PLANNING BOARD REPORT PORTLAND, MAINE

Jewish Community Center and Preschool/Daycare 1342 Congress Street

Conditional Use & Level III Site Plan Review

Project # 2015-058

The Site Plan below (and in [Plans P5 and P6](#)) includes:

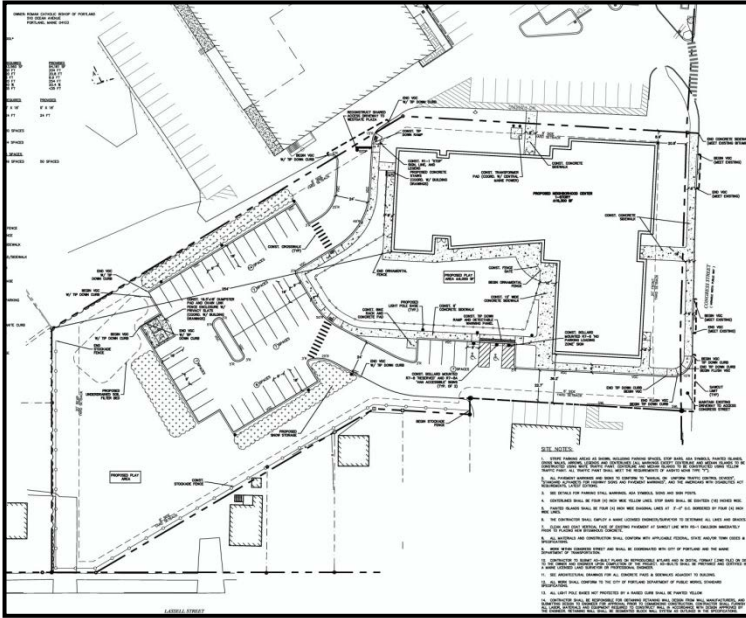
- *The driveway entering the site from Congress Street is noted as having a width of 22.7 feet. This width (in the area where parking maneuvers occur) does not meet City standards and thus a formal waiver should be requested by the applicant.*

- *I would suggest a tip-down curb entering the driveway on Congress Street, as currently provided.*

Status: The curb ramp layout should be revised so that the ramp flare does not impact accessibility along the sidewalk route. Having a tip-down design will help to address this issue.

- *The applicant shall consider the formal delineation of the driveway along the medical office property boundary, when entering from Congress Street.*

- *The pick-up and drop-off of daycare and others will need to be carefully managed. Accordingly, the applicant should provide specific details on how this process will take place. This should include what building entrances will be used, sidewalk facilities between parking spaces and the noted entrance, etc. I would note that the pick-up/drop-off program must be managed such that vehicles are not parking along the driveway off Congress Street.*

Status: I have reviewed existing JCA activity at their current Portland site and I have recommended that a barrier be constructed that prevents pedestrians from accessing the building entrance near Congress Street. The applicant has revised the site plan to include a 18" sitting wall along the curb. While the height of the wall is mountable by pedestrians, I do believe the physical presence of the wall will deter drop-off and pick-up activity near Congress Street. Accordingly, I find conditions to be acceptable.

Status: I find the proposed driveway width to be acceptable given that most vehicles will be passenger cars and that a secondary driveway via the Westgate Shopping Center will be provided. I support this waiver request.

Status: The site plan has been revised and I find conditions to be acceptable.

- iii. That the applicant revise the curb ramp layout at Congress Street in accordance with the comments of Tom Errico dated June 26, 2015, with revised plans to be reviewed and approved by the Planning Authority prior to the issuance of a building permit; and

Final for hearing (see also Plan P6)

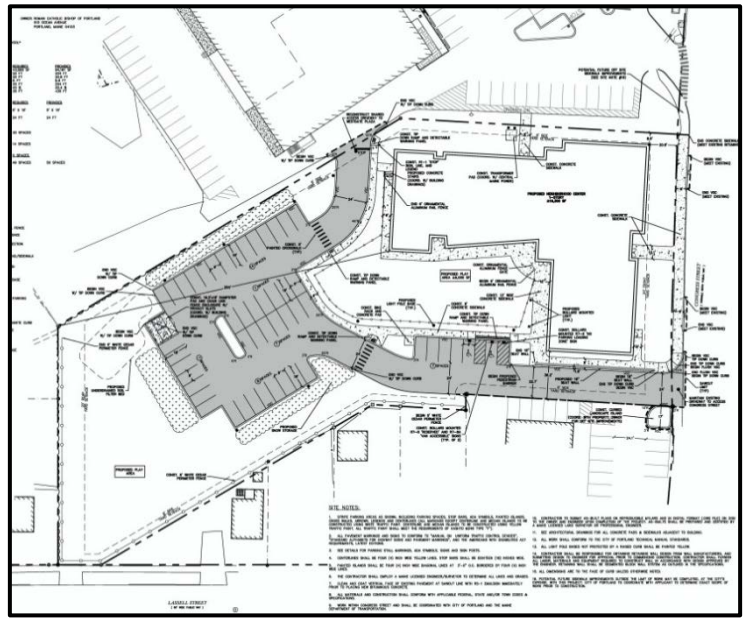
Added since the Workshop: (see comparison of plans below)

- 17 foot wide curbed landscaped island to delineate the driveway off of Congress Street
- Incorporated a barrier along west side of the main drive to prevent cars stopping to drop off
- Additional planting
- Revised lighting to reduce trespass
- Revised stormwater management and treatment
- Revised the elevations
